SOLICITATION AMENDMENT MODIFICATION DE L'INVITATION

Title - Sujet CCGS Samuel Risley refit 2014	
Solicitation No. - N° de l'invitation F2599-145028/A	Amendment No. - N° modif. 014
Client Reference No. - N° de référence du client F2599-145028	Date 2014-07-03
GETS Reference No. - N° de référence de SEAG PW-\$\$MD-018-24496	
File No. - N° de dossier 018md.F2599-145028	CCC No./N° CCC - FMS No./N° VME
Solicitation Closes - L'invitation prend fin at - à 02:00 PM on - le 2014-07-16	Time Zone Fuseau horaire Eastern Daylight Saving Time EDT
F.O.B. - F.A.B. Plant-Usine: <input type="checkbox"/> Destination: <input type="checkbox"/> Other-Autre: <input type="checkbox"/>	
Address Enquiries to: - Adresser toutes questions à: Vandal, Paul	Buyer Id - Id de l'acheteur 018md
Telephone No. - N° de téléphone (819) 956-0645 ()	FAX No. - N° de FAX (819) 956-0897
Destination - of Goods, Services, and Construction: Destination - des biens, services et construction:

QUESTIONS AND ANSWERS

CONFÉRENCE DE SOUMISSIONNAIRES
BIDDERS' CONFERENCE

GREY WATER LAYOUT DIAGRAM

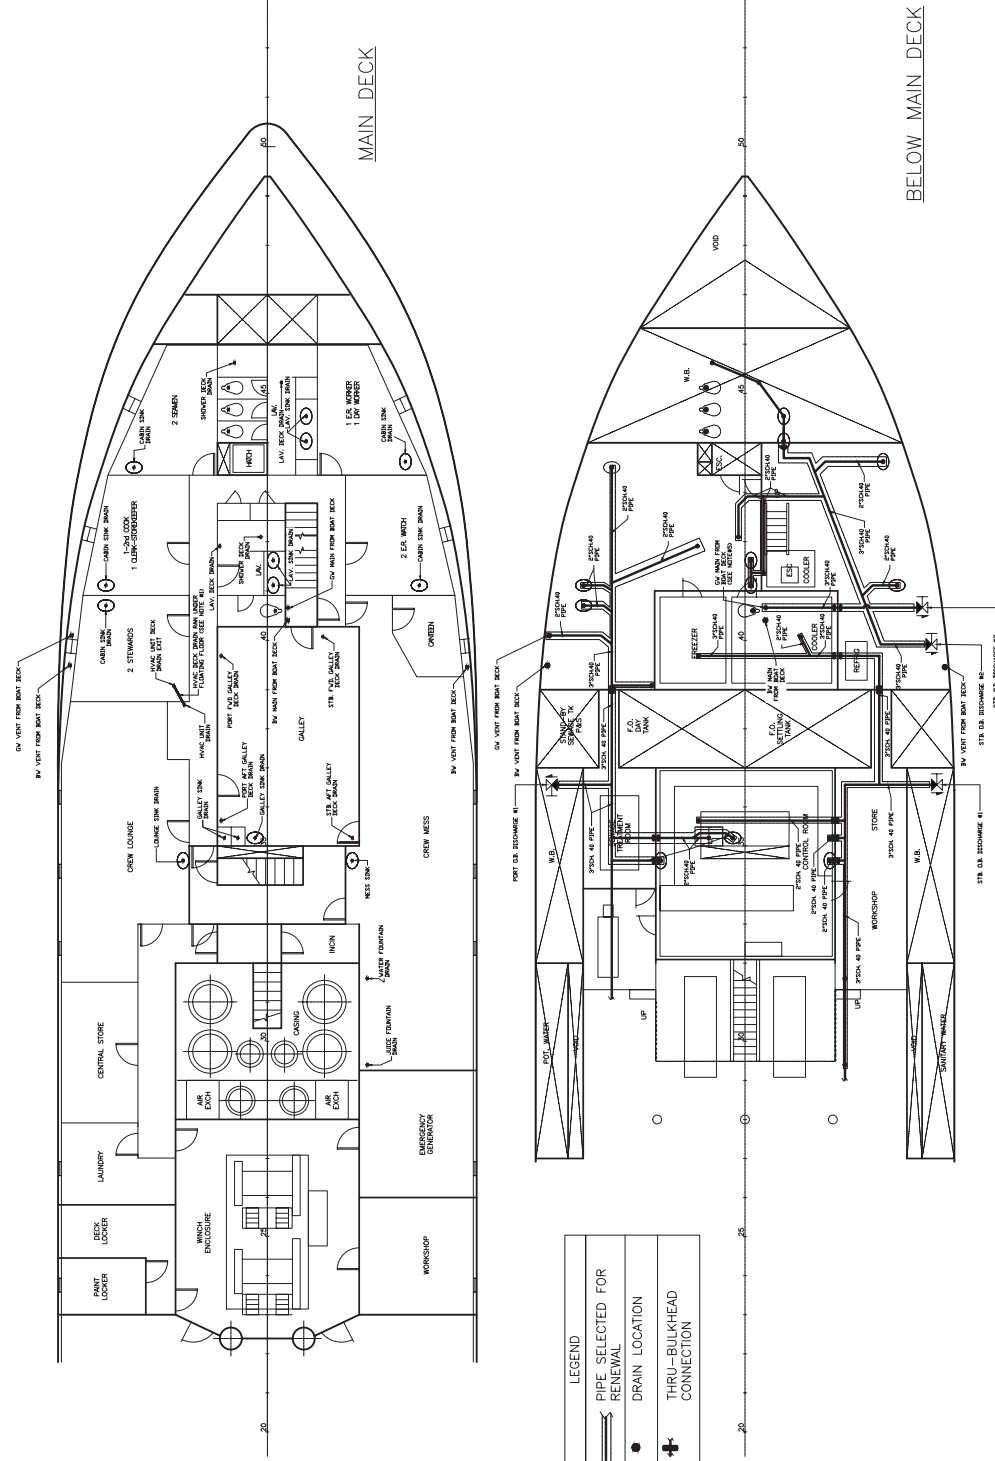
Under Section 8 it identifies galvanized Schedule 80 steel for Black and Grey Water piping replacements. Is this material specification firm, or can the successful Shipyard suggest another material option for this piping?

Please see revised drawing to reflect the pipe schedule change - Spec. Section 8.0.

- NOTES:
- 1) HVAC DECK DRAINS RUNS BETWEEN MAIN DECK AND FLOATING FLOOR DECK TO AVOID PENETRATING FUEL TANK
 - 2) ALL THRU-DECK VENTS SHALL BE REPLACED TO 12 ABOVE MAIN DECK ACCEPT WHERE NOTED.
 - 3) ALL REPLACEMENT DRAIN PIPES SHALL BE GALVZINIZED SCH 40 PIPE WITH ENDS MILLED TO ACCEPT VITACULIC COUPLINGS. BULKHEAD AND DECK PENETRATIONS TO BE GALVZINIZED SCH 80 PIPE AS SHOWN ON DWG #0536 PIPE PENETRATION DETAIL.
 - 4) ALL REPLACEMENT DRAIN PIPES SHALL UTILISE GALVZINIZED VITACULIC COUPLINGS FOR ALL JOINTS, ELBOWS ETC.
 - 5) THRU-DECK GW MAIN IN THIS LOCATION SHALL BE REPLACED UP TO COUPLING AS NOTED ON BW AND GW DRAIN DIAGRAM.
 - 6) ALL PRING SHALL BE INSTALLED WITH A MINIMUM 5 DEGREE SLOPE TO PROVIDE PROPER DRAINAGE.
 - 7) ALL DRAINS SHALL BE PROVIDED WITH TRAPS.
